Rezoning Transportation Analysis

Petition Number: 2018-155

General Location Identifier: 20109115

Revision Log:	Date	Description
	01-18-19	First Review
	02-18-19	Second Review
	03-27-19	Third Review

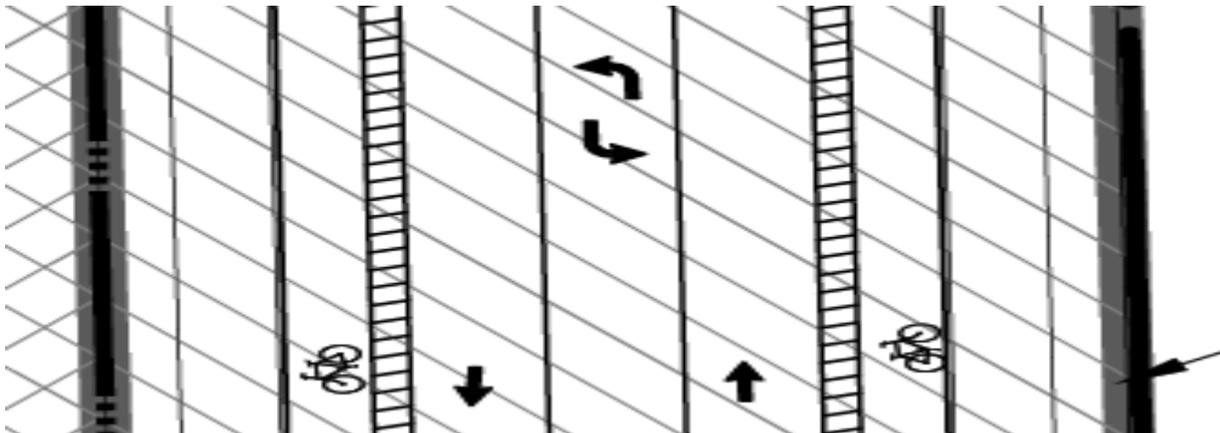
4. The petitioner shall revise the site plan and conditional notes stating the commitment to building the correct cross-section of Dixie River Road. Dixie River Road is a major thoroughfare with a cross-section of:

- a. 2-11' thru lanes
 - b. 1-11' center turn lane
 - c. 2-8' Buffered bike lanes
 - d. 2.5' curb & gutter
 - e. 8' planting strip
 - f. 8' sidewalk.

See cross-section below:
